# Staff Summary Report

**SUBJECT:** Hold a public meeting for a Development Plan Review for **AGAVE CENTER – CARL’S JR. RESTAURANT** located at 8825 South Jewel Street.

**DPR11217 --** Development Plan Review including site plan, building elevations, and landscape plan.

**AGAVE CENTER - CARL'S JR RESTAURANT (PL090412)**

PROJECT NO. 2011020  
 DATE: 08-29-11  
 rev. by: checked by: date:  
 TITLE:  
 DRAWN BY:  
 TMM  
 DRAWING TITLE:  
 EXTERIOR ELEVATIONS  
 DRAWING NUMBER:

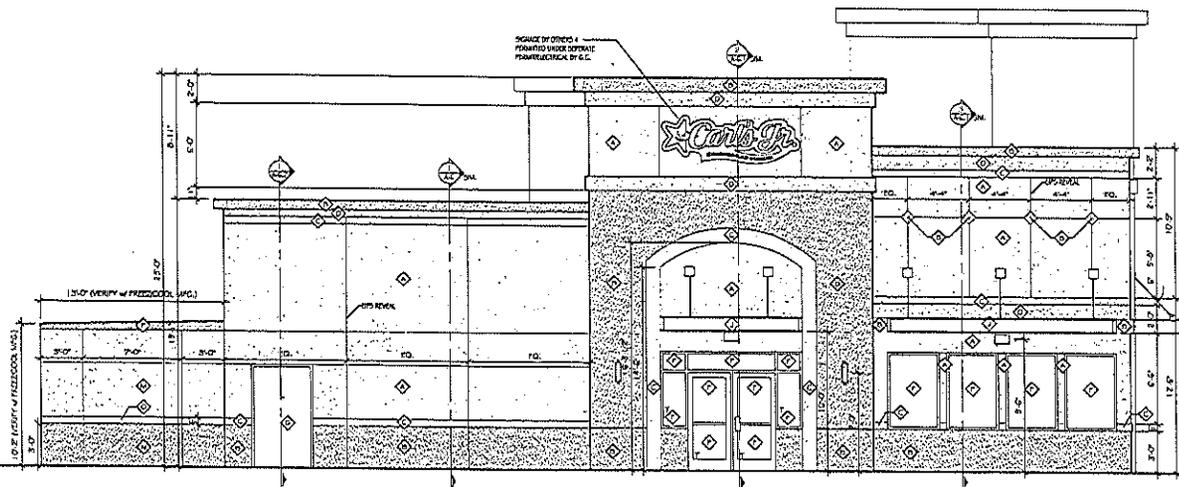
8. Correctly label building elevations.
9. Enclose electrical service entrance section inside a pop-out so the section is concealed, except expose doors flush with front of pop-out. Provide pop-out of matching materials and colors to the building and architecturally integrate the design of the pop-out with the building. Details of pop-out to be approved during building plan check process.

10. Resolve facade details; do not allow material or banding color at outside corners. All material changes should be at the inside corners.
11. Detail inside of raised parapets to be the same material as the exterior face of parapet.

12. At east building elevation, paint the service door "Steady Brown" to match the building base color.
13. The materials and colors are approved as presented:
